# *Camden Residents' Action Group*

Re: DA 2018/1192/1

Alterations/additions to an existing service station including installation of underground tank for fuel storage, construction of a new canopy over the diesel pump area and installation of a replacement ID sign

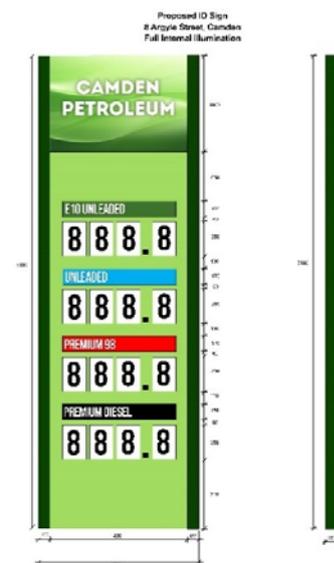
The Applicant responds that the new canopy has a setback of over 15m, and will pose no visual obstruction or impact on the site or surrounding area.

CRAG comment: it is understood that the awning over the diesel pumps is an environmental requirement to prevent rain causing spillage and contaminated water entering the wetlands and billabong. A setback of 15 metres should not cause visual obstruction and also obviate much visual impact on the character of the HCA.
